# NEW MEXICO OIL CONSERVATION DIVISION

SUBJECT: REQUEST FOR APPROVAL OF NON-STANDARD LOCATION FOR GOLDEN SPUR 36 COM W1 2H

WELL LOCATION AND ACREAGE DEDICATION PLAT

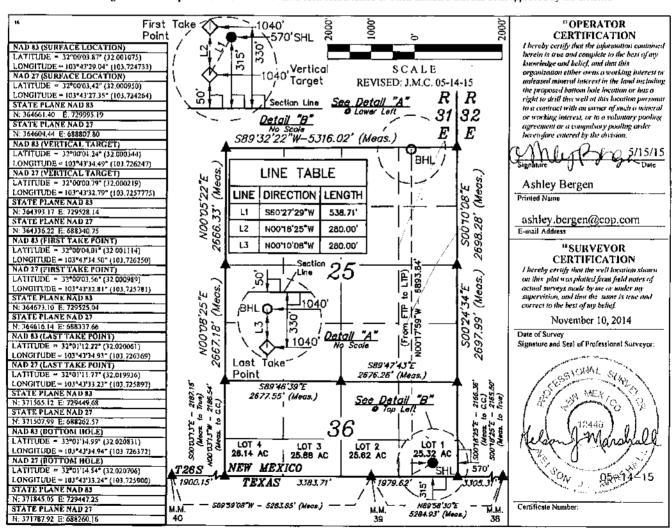
Why is the NSL location better than a standard location? This would be the reason for NSL application.

Why are you applying for the NSL?

Is the NSP required, because the Lot in Section 36 is less than 28-acres?

Do we want overlapping project areas-we would be giving TWO allowables for each spacing unit in Section 25, Mike

The Bureau of Land Management encouraged this location to be used because of cave/karst considerations and to avoid nearby drainage ditches. The granting of this request is not expected to cause waste of resources.

We are 50' too close to the project area (208' from project area border on the west side) and yes Lot 1 in Section 36 is less than 28 acres.
